December 7, 2018

**RE: Revised Site Plan Submittal
2904 & 2914 Acushnet Avenue
New Bedford, MA 02745**

Please find enclosed with this letter, site plans entitled “Site Plan – 2904 & 2914 Acushnet Avenue – Assessors Map 130D Lots 117, 247, 248 & 447 – New Bedford, Massachusetts” last revised 12/07/18 by Farland Corp. These plans have been revised in response to comments provided in the City of New Bedford Department of Planning, Housing & Community Development Staff Report dated December 4, 2018. Plans have been revised in the following manner:

SITE DEMOLITION PLAN
 CFG03.0

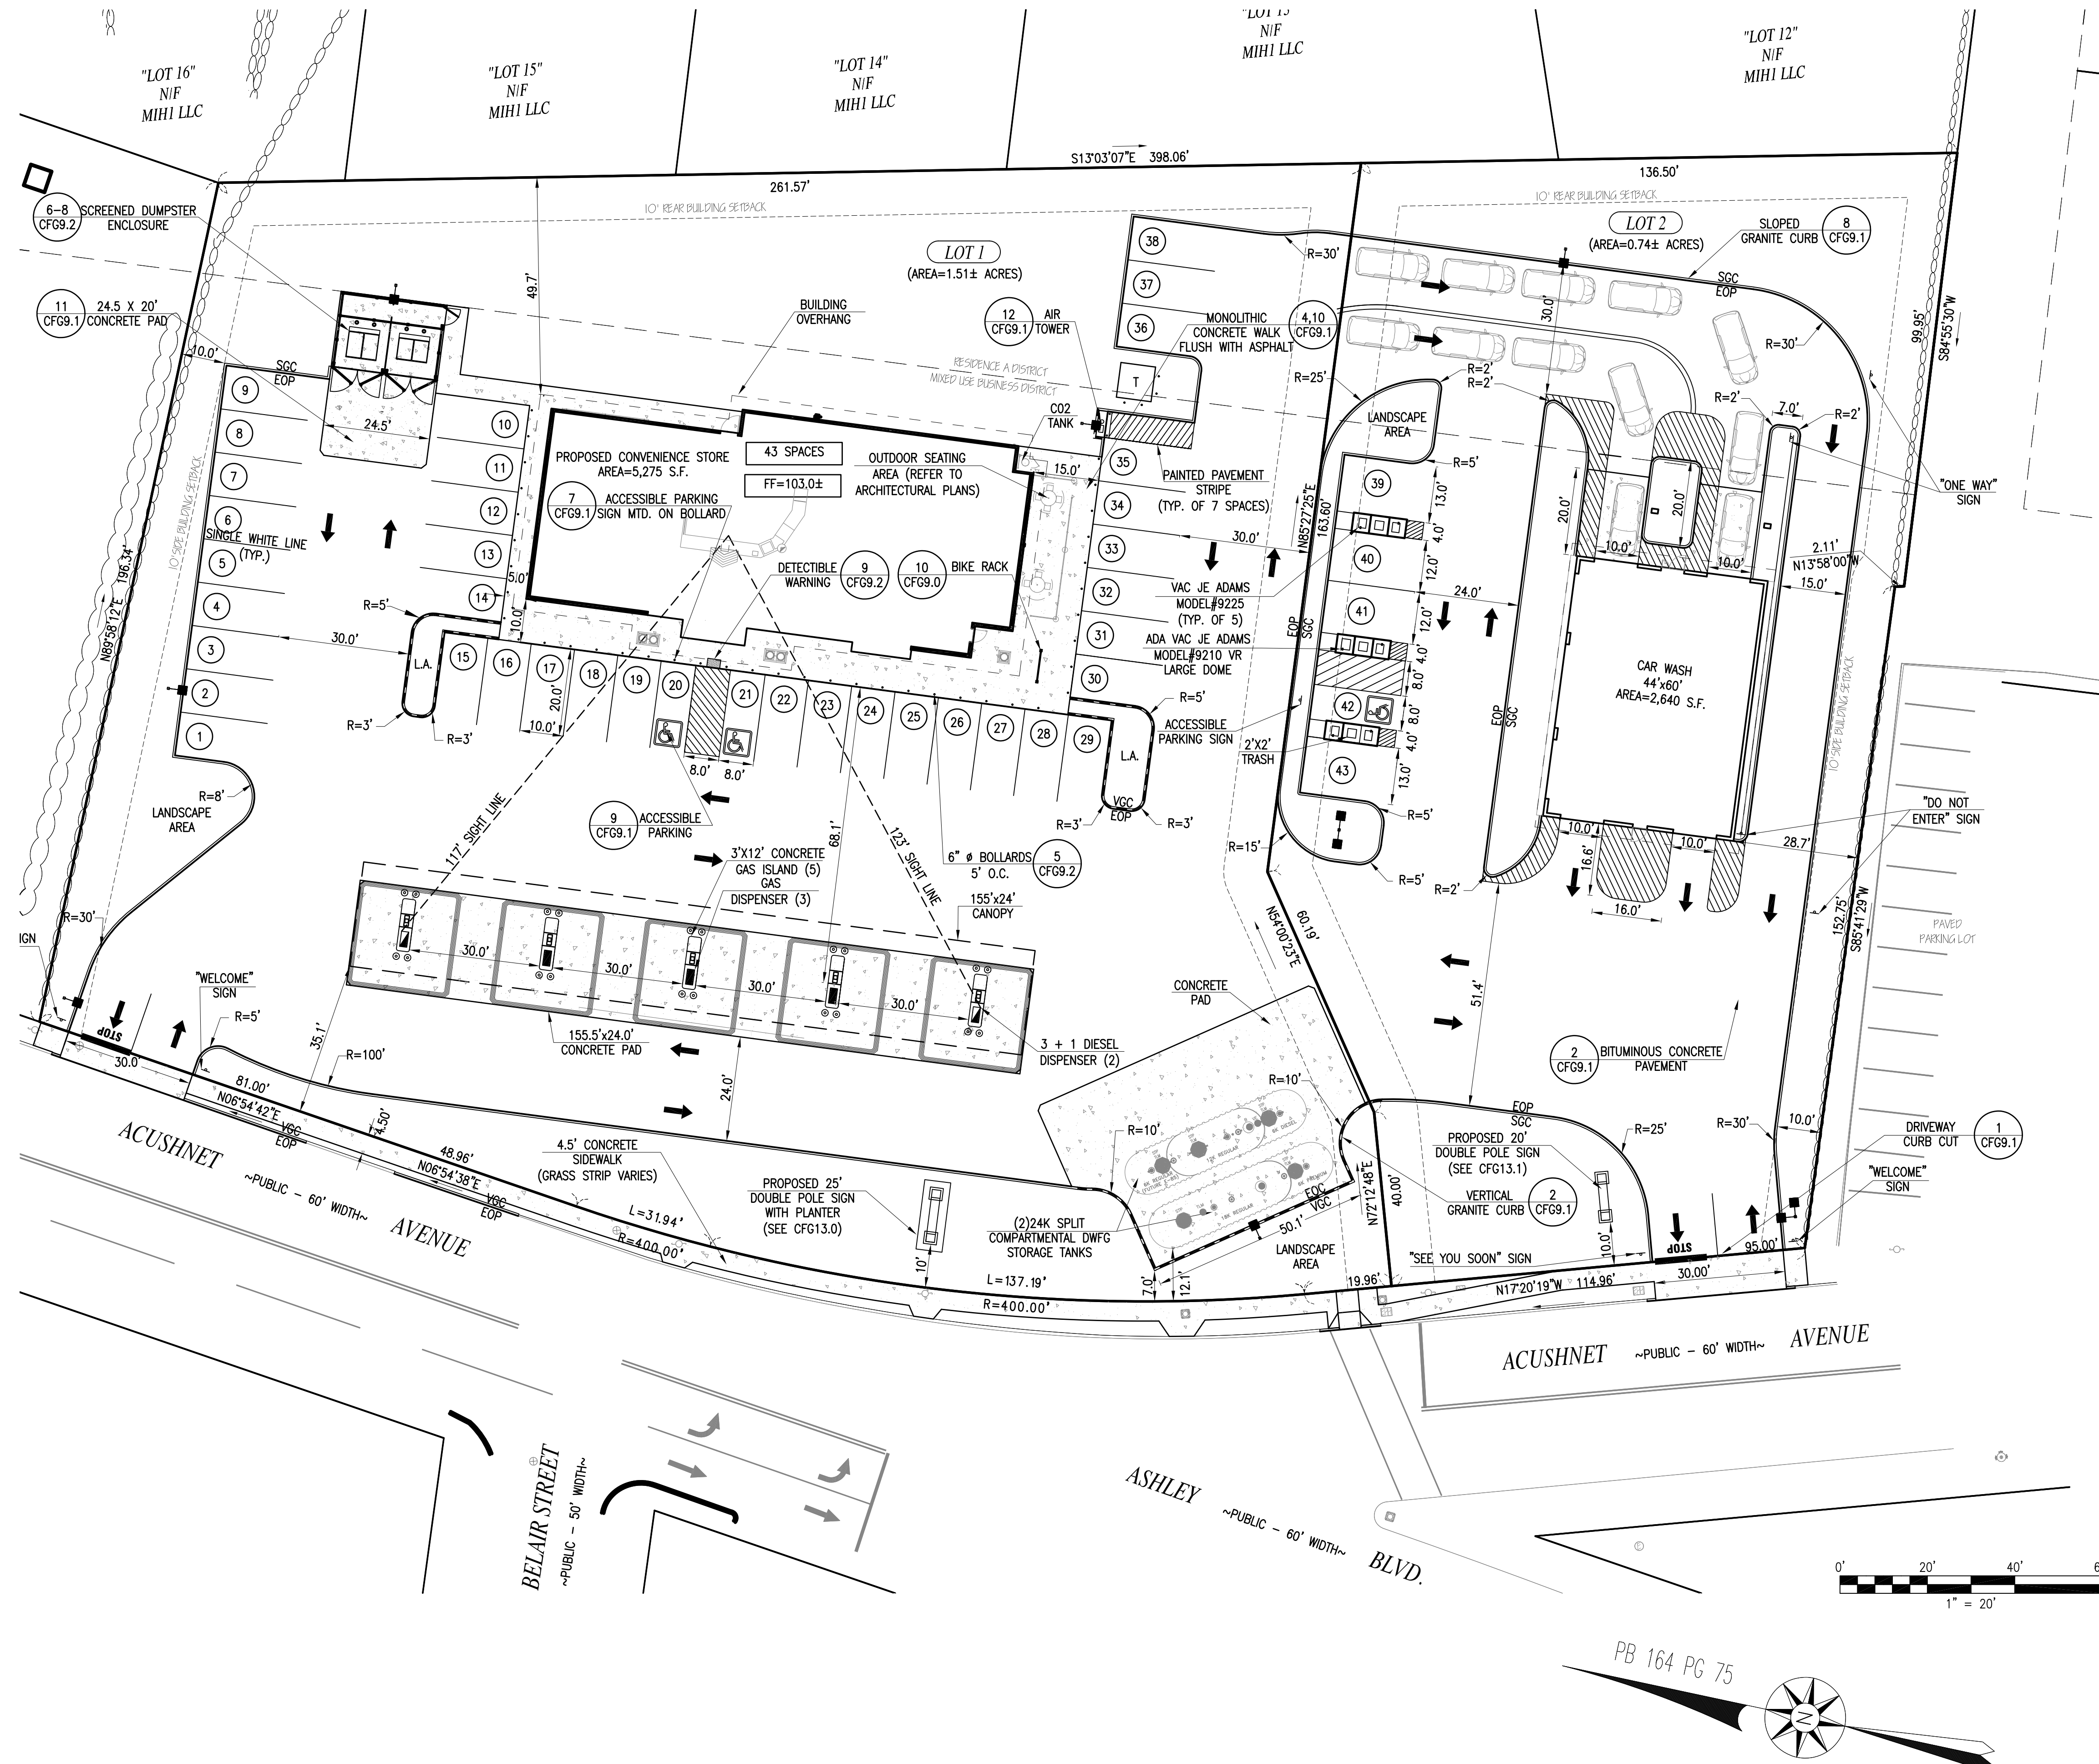
1. Stone walls to be retained on the north and south property lines are shown on the plans (Refer to CFG 3.0-8.0).
2. A bicycle rack has been shown on the plan within the concrete walk on south side of proposed convenience store building (Refer to CFG 4.0).
3. Pavement markings have been revised to ensure proper site circulation (Refer to CFG 4.0).
4. The property line separating the “car wash” lot and the “convenience store” lot has been shown on the plan (Refer to CFG 4.0).
5. Three additional parking spaces have been added to the east of the proposed air tower and transformer pad (Refer to CFG 4.0).
6. Numbered parking spaces at proposed fuel dispensers have been removed (Refer to CFG 4.0).
7. Proposed landscaping in the area of the proposed car wash sign has been revised (Refer to CFG 8.0).
